Region 10 Enforcement and Compliance Assurance Division
1200 6th Avenue
Seattle, WA 98101
INSPECTION REPORT

Inspection Date:	02/24/2021	
Time:	Entry: 8:30 a.m.	Exit: 9:30 a.m.
Media:	Water	
Regulatory Program:	CWA NPDES/Construction Stormwater	
Operator Name(s):	Barber Valley Development – (Notice of Intent IDR1002LG)	
Operator Addresses:	4940 East Mill Station Drive, Suite 101-B	
Operator City, State, Zip Code:	Boise, Idaho 83716	
Site Name:	Dallas Harris South Subdivision No. 1	
Site Physical Location:	East Warm Springs Avenue, City of Boise, Idaho, approximately 5 miles southeast of downtown Boise	
	Latitude/Longitude	43.56971°N, 116.130364°W
City, State, Zip Code:	Boise, Idaho 83716	
Site Contact(s):	Kyle Terrell, Project Manager Phone: (208) 338-0818 Email: kyle@centralpaving.com	Central Paving Co., Inc.
County:	Ada County, Idaho	
Site Identifier:	Dallas Harris South Subdivision No. 1	
Estimated Site Area to be Disturbed:	5.5 acres	
Site Receiving Water(s)	Warm Springs Creek	
Site Receiving Water(s) Description:	Creek

NPDES Permit:	2017 EPA Construction General Permit (CGP)	
EPA Site Tracking Numbers:	IDR1002LG	
Notice of Intent (NOI) Site Timeline(s):	Start Date: 07/23/2020

Photograph 1. View, facing north, of Warm Springs Creek located on the southern perimeter of the Site west of East Millbrook Way. The fiber rolls are installed upgradient of the hydro seeded area next to the creek.

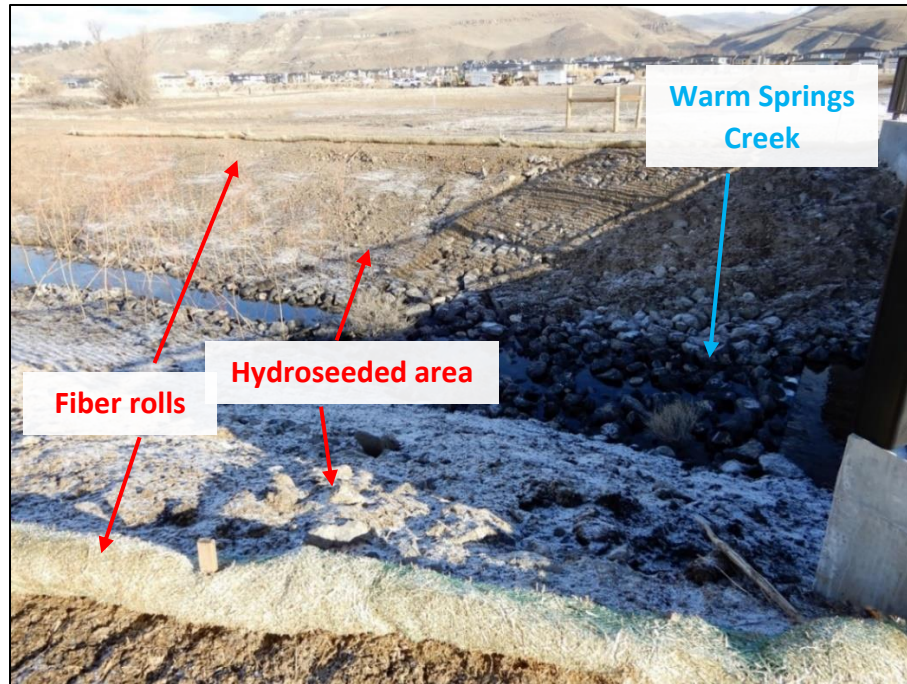
We observed that the fiber roll BMPs along the southern perimeter were not properly installed or maintained in accordance with good engineering practices. On the Site's southern perimeter, to the west and east of East Millbrook Way, we observed fiber rolls installed upgradient of the hydro seeded area along Warm Springs Creek to provide protection to the creek while vegetation was established. Fiber rolls were not located downgradient, allowing sediment and pollutants to potentially enter Warm Springs Creek (refer to [Attachment A, Photographs 1 through 4](#)).

After the inspection on March 3, 2021, Mr. Terrell sent the Inspection Team three pictures of the corrected BMPs (refer to [Attachment B, Exhibits 3 through 5](#)).
